## Modernization Kit No. 4750218 Power Jet Package

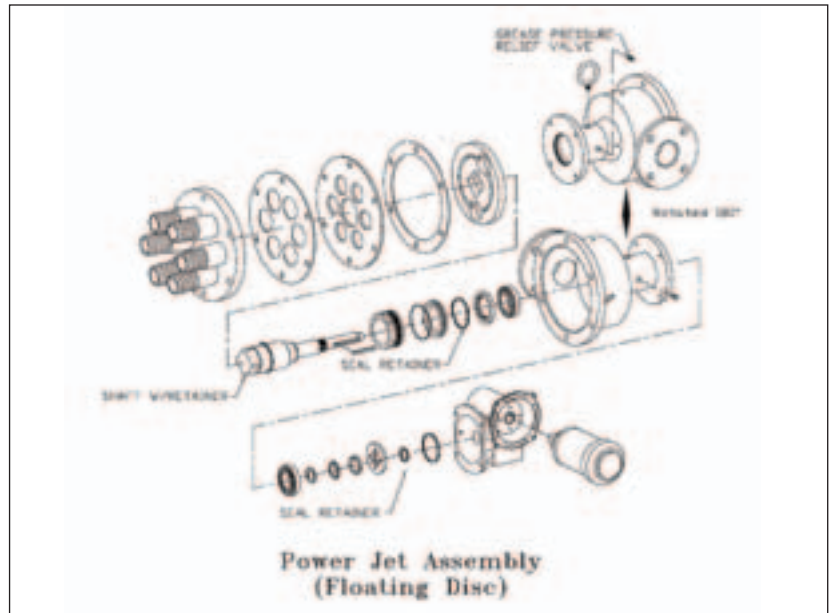
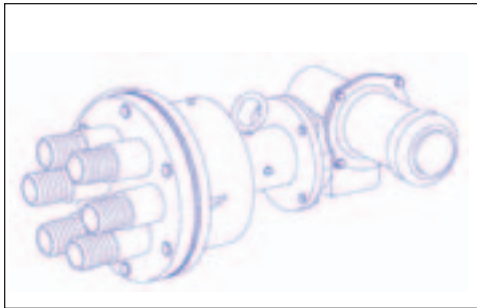
Barry-Wehmiller now offers a modification to existing Power Jet assemblies that will prevent seal failure due to overlubrication and allow easier overhaul access. This modification provides the following:

- Grease Pressure Relief Valve - prevents over lubrication by allowing the grease to escape the cavity through the valve before pushing out the grease seals.
- Shaft Modifications - positive seal and bearing placement simplifies installation.
- Retaining Rings - holds the mechanical seal and two grease seals in place.

This modification requires complete power jet disassembly and machining of the body and shaft. The factory will completely overhaul the power jet and make the changes necessary to incorporate this modification. Send your power jet to Barry-Wehmiller for modification and a factory overhaul.
